ERRATA SHEET

DS26518

Revision A2 Errata

Figure 1

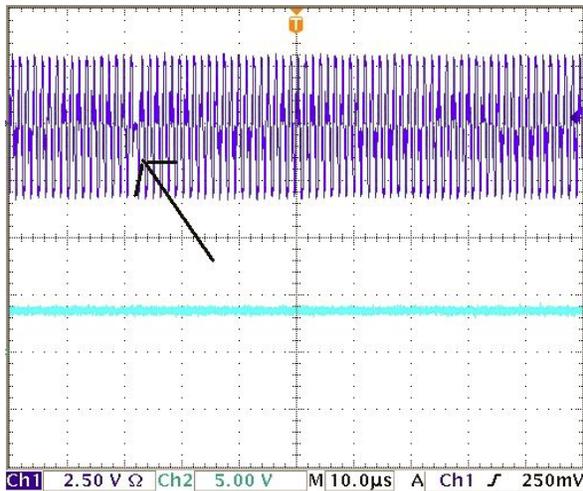
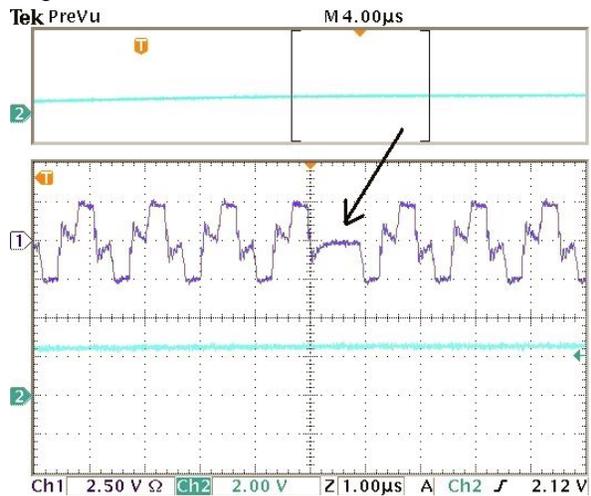
The TTIPn/TRINGn line drivers should be high impedance whenever TXENABLE is low. On rev A2 devices, the TTIPn/TRINGn line drivers are briefly enabled during power-up, even if TXENABLE is low. This may cause the inactive DS26518 in a Y-cable application to attenuate the transmit waveform of the active DS26518 and create a bit error, as seen in the figures below.

None.
